## Issue List

**02-09-26 QT #0489 CASA GRANDE, AZ**

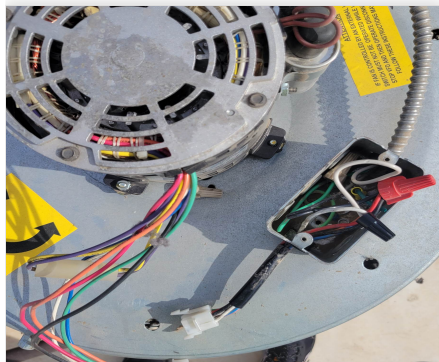
**Issue Name :** CONDENSER DRAIN IN THE WAY OF DOOR  
**Description :** The door to the mixed air compartment cannot be opened very far, due to the drain being in the way. The economizer control could barely be reached. Recommend adjusting drain to allow full access.  
**Created By :** National TAB                      **Assigned To :** National TAB - Dan Hertenstein  
**Status :** Open  
**Priority :** Low                                      **Asset Tag :** RT-3  
**Originated Date :** 02/13/2026 - Christine Weale - National TAB

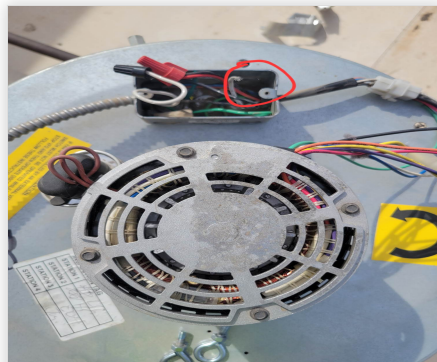
**Issue Name :** EF1 NO SPEED CONTROLLER  
**Description :** When I arrived, EF1 was improperly wired and not running, I fixed it, but it was running way too high so I disconnected the fan for safety. There should be a safety disconnect switch and a speed control. Possible fan speed may also be controlled via wiring. No disconnect switch, so power unplugged at the motor connector.  
**Created By :** National TAB                      **Assigned To :** National TAB - Dan Hertenstein  
**Status :** Open  
**Priority :** Urgent                                      **Asset Tag :** EF1  
**Originated Date :** 02/13/2026 - Christine Weale - National TAB
